TOWN OF  
**BRECKENRIDGE**

**Planning Commission Meeting Agenda**

Tuesday, August 7, 2018, 5:30 PM

### Site Plan Landscape Plan

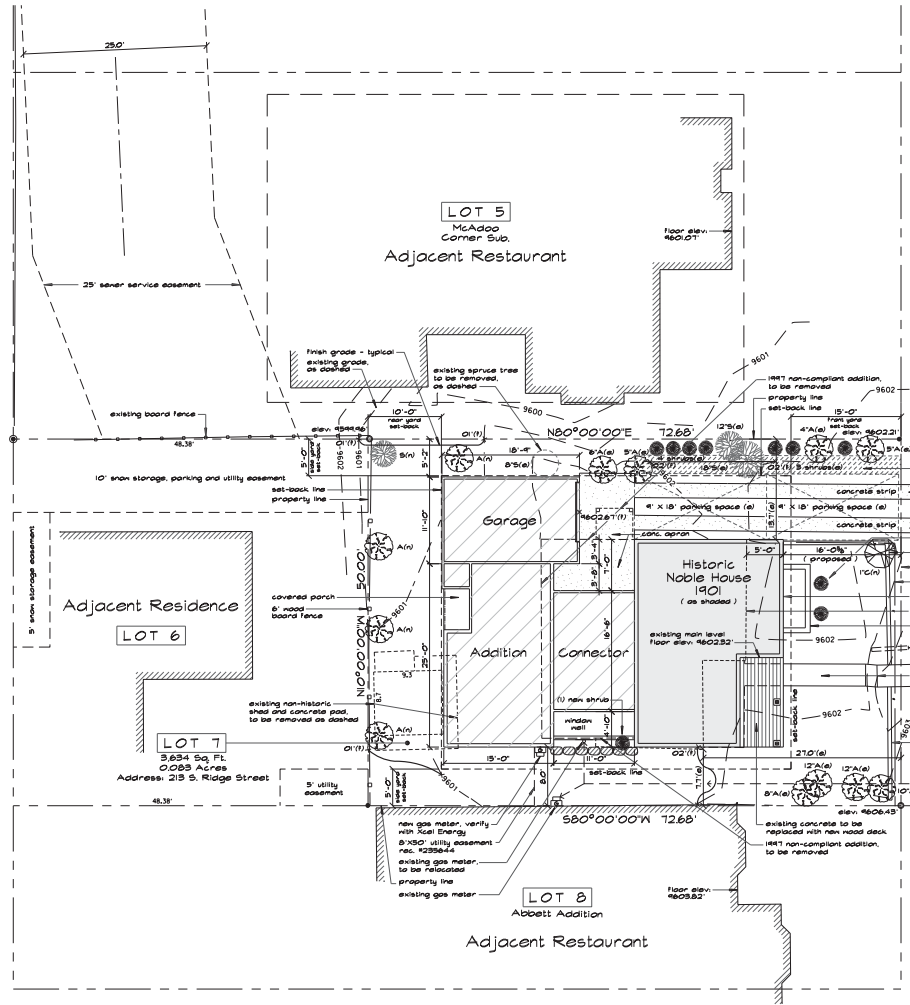
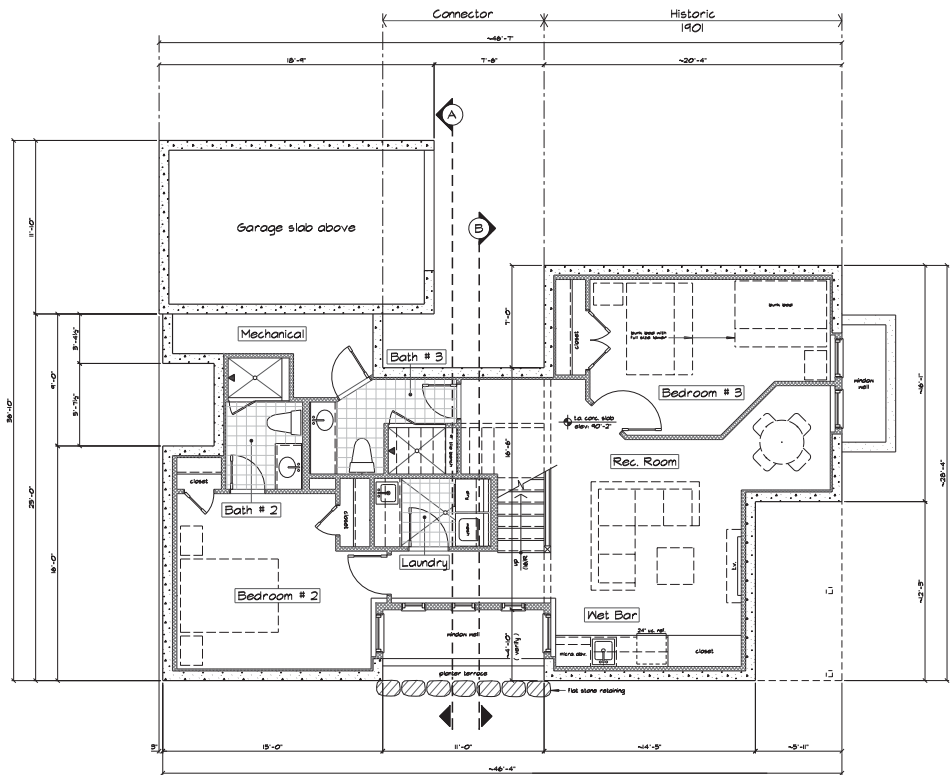
- Removal of a Spruce tree should be shown on the Site Plan
- Whether or not the proposed “barn” area should be counted towards “density”
- Driveway and associated snow storage

**Snow Removal and Storage (13/A & 13/R):** The proposed site plan now designates 70 sq. ft. of snow storage for the driveway. However, snow storage for the 48 sq. ft. front entry walkway is also required to be provided, for a total of 82 sq. ft. Staff requires that snow storage be designated on the site plan for the front entry walkway, prior to the Final Hearing.

**Fences, Gates And Gateway Entrance Monuments (47/A):** There is an existing 6' wooden board fence on the lot, which does not comply with the height or spacing standards in the Handbook of Design Standards, Standards #60-62. A survey submitted by the applicant shows the fence to be on the lot, and therefore it is non-conforming and must be brought into conformance with this application. Staff will add a Condition of Approval that the fence must be removed prior to issuance of a Certificate of Occupancy. The lot also contains a compliant existing 3' tall metal fence enclosing most of the existing front yard, except for the southern boundary. Some portions of the fence will likely be removed to accommodate the proposed relocation of the existing structure 5' to the east.

**Figure 1. Block 11 Traffic Calming Locations**

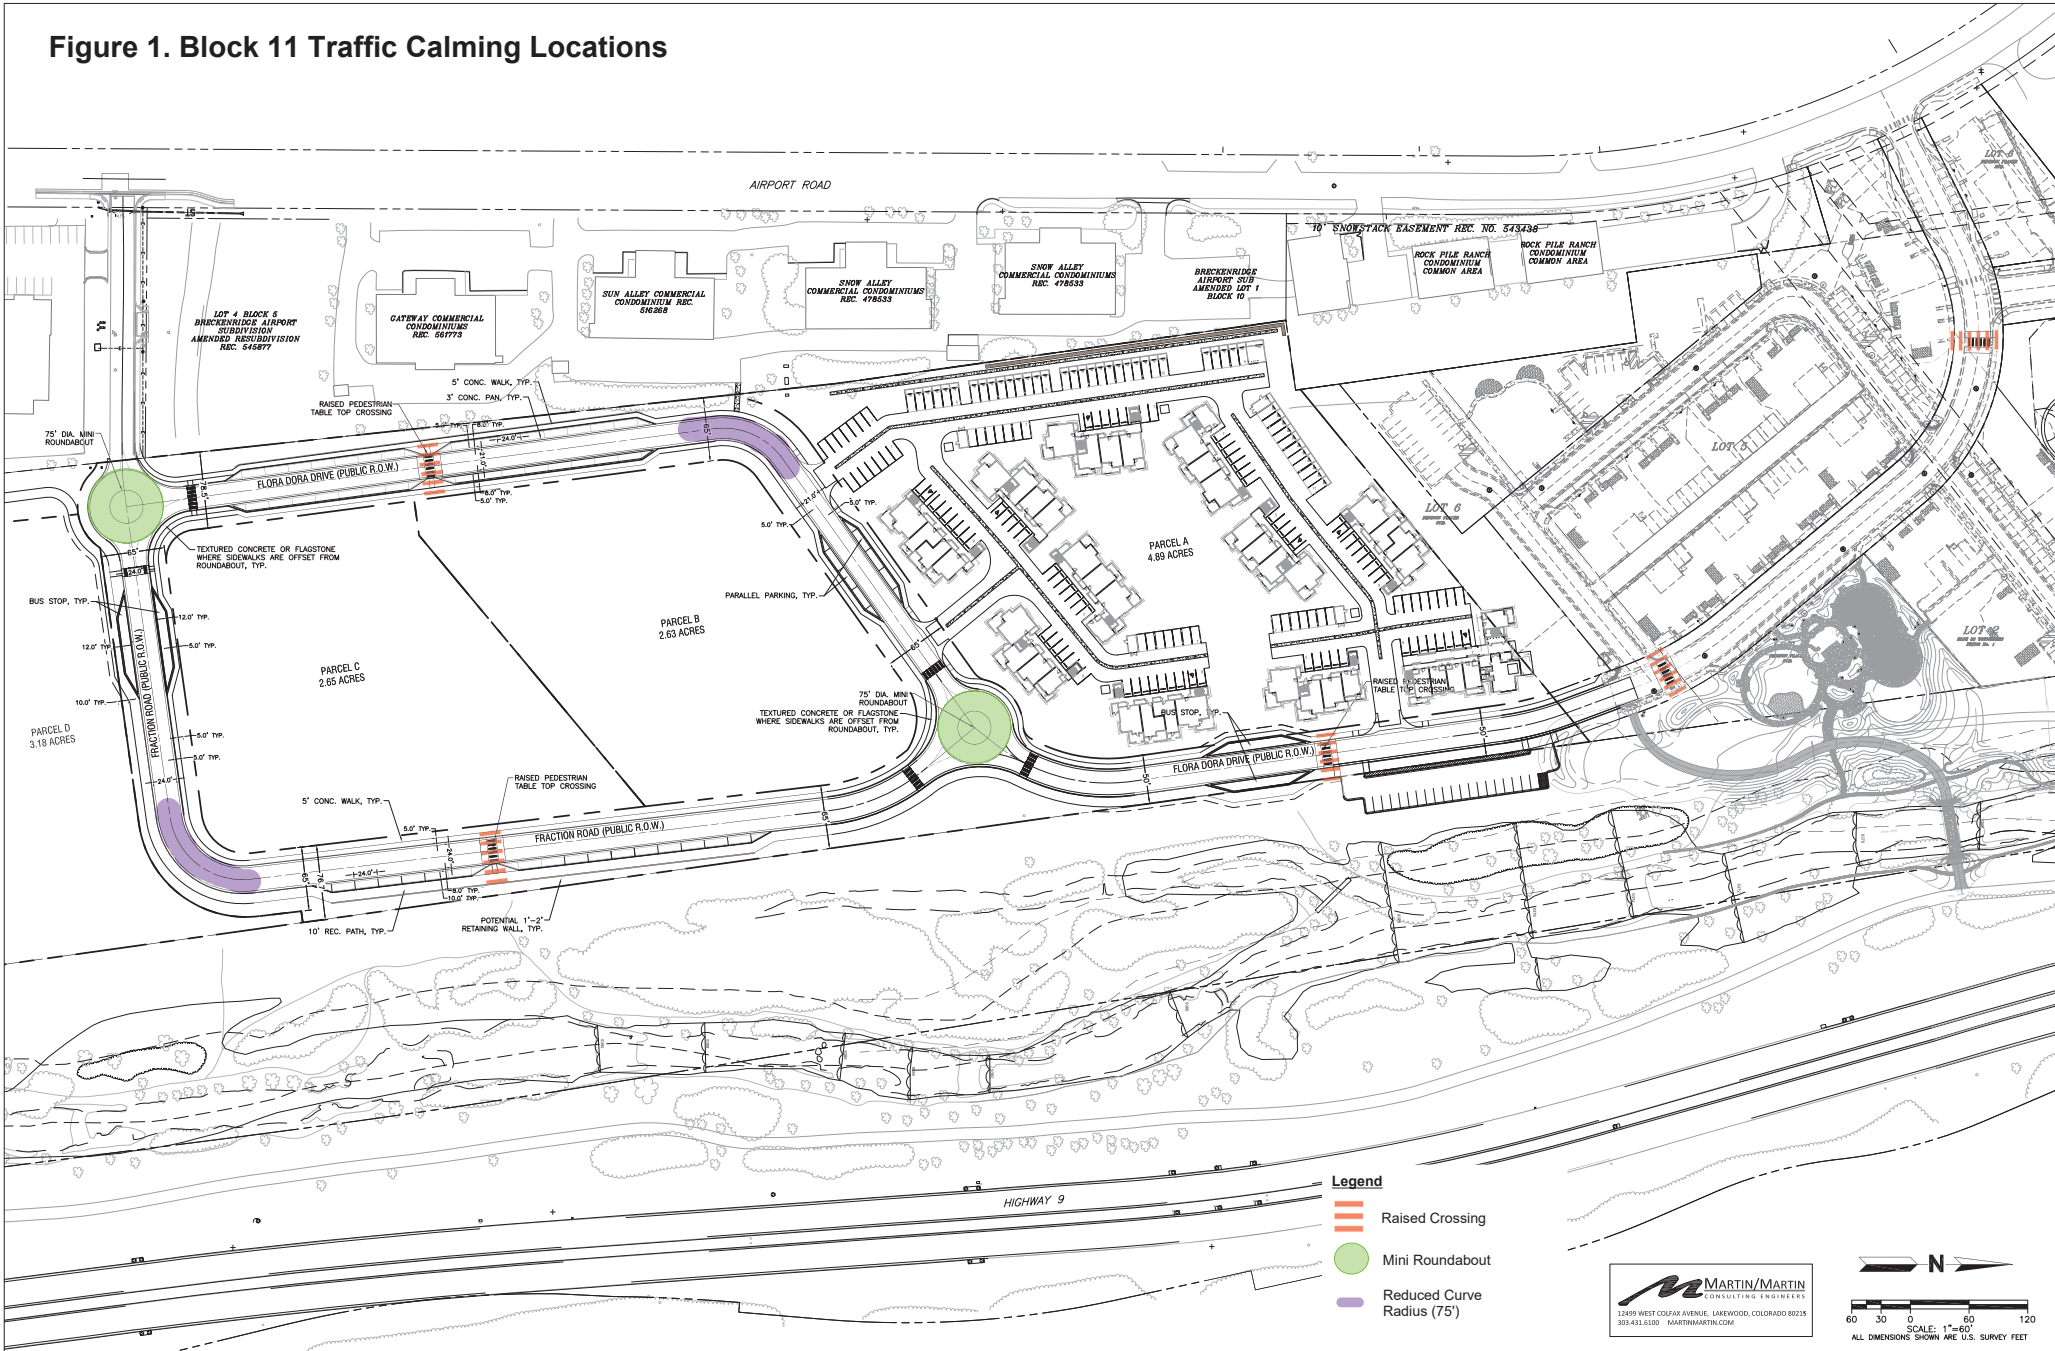
After meeting with Town of Breckenridge staff, Fehr & Peers was able to recommend the appropriate traffic calming devices for the Block 11 Neighborhood. **Figure 1** displays the locations and types of traffic calming devices to be in the Block 11 Neighborhood. Mini roundabouts, raised crossings, and small radius curves are planned to be implemented and are described in greater detail below.

In summary, the recommended mini roundabouts, raised crossings, and small radius curves will provide traffic calming to minimize vehicular speeds throughout the new Block 11 neighborhood with minimal impacts to users who need to access Block 11, including buses and people visiting the Blue River. These types of traffic calming devices can also be retrofitted on other existing Town streets in the future.
